**SHEARON HARRIS NUCLEAR POWER PLANT, UNITS 2 AND 3  
DOCKET NOS. 52-022 AND 52-023  
SUPPLEMENT 2 TO RESPONSE TO REQUEST FOR ADDITIONAL INFORMATION LETTER  
NO. 021 RELATED TO EMERGENCY PLANNING**

**Shearon Harris Nuclear Power Plant Units 2 and 3  
Supplement 2 to Response to NRC Request for Additional Information Letter No. 021  
Related to SRP Section 13.3 for the Combined License Application,  
dated September 26, 2008**

**NRC Review of Evacuation Time Estimate Report**

**NRC RAI #:** 13.03-21

Figure I-1: Evacuation Plots for Scenario 3 (Base) and Scenario 13 (Peak Fest) for the Evacuation of the Entire EPZ (Region 3)

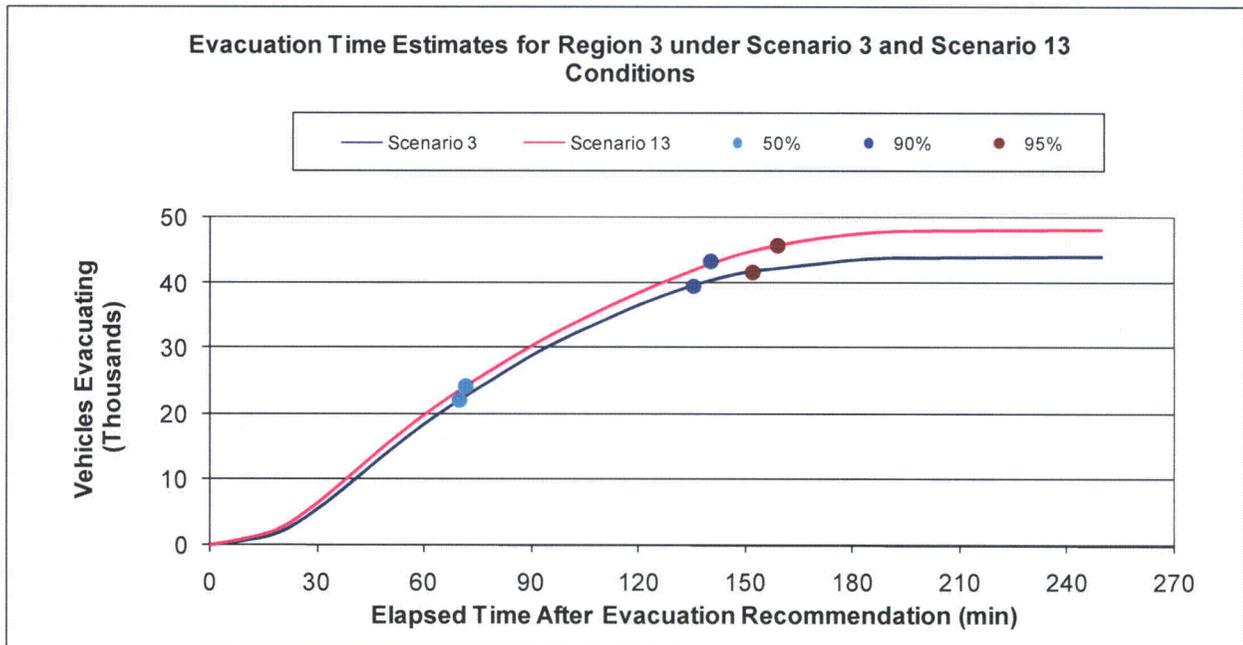
Clarify Section 2.2, Study Methodological Assumptions, Assumption 6, that indicates that there are no peak tourist events that should be considered. Peak Fest, which is held every May in Apex, North Carolina, has an annual attendance of as many as 25,000 people.

- a. Discuss why there are no special events listed and why peak tourist populations are not included in the transient population estimates in Section 3.
- b. Explain what resources were used to determine the special events.
- c. Identify the effect on the ETE of the peak tourist volume listed here, or other events that might be identified through research that may have greater peak tourist volumes.
- d. Clarify Section 2.2, Assumption 6. Discuss why there are no special events listed and why peak tourist populations are not included.

A sensitivity study was conducted to estimate the impact of transients attending Peak Fest on the ETE for an evacuation of the entire EPZ (Region R03). The results of this study are attached and will be included in Appendix I of the revised ETE report. As indicated in Table I-5 of the attached, the ETE increased by 5, 10, 10 and 5 minutes for the 50<sup>th</sup>, 90<sup>th</sup>, 95<sup>th</sup> and 100<sup>th</sup> percentiles of evacuating population, respectively. The additional transients present in Apex for Peak Fest prolong the congestion within Apex; however, the ETE for the entire EPZ is not materially affected.

Table I-5 compares the 50<sup>th</sup>, 90<sup>th</sup>, 95<sup>th</sup>, and 100<sup>th</sup> percentile ETE for the Special Event with the ETE for the base case. The additional transient vehicles present for Peak Fest increase the ETE by 5, 10, 10 and 5 minutes for the 50<sup>th</sup>, 90<sup>th</sup>, 95<sup>th</sup> and 100<sup>th</sup> percentiles, respectively.

Figure I-1 is a plot of vehicles evacuating over time after the advisory to evacuate for Region 3, under Scenario 13 (Peak Fest) and Scenario 3 (summer, weekend, midday, good weather) conditions.
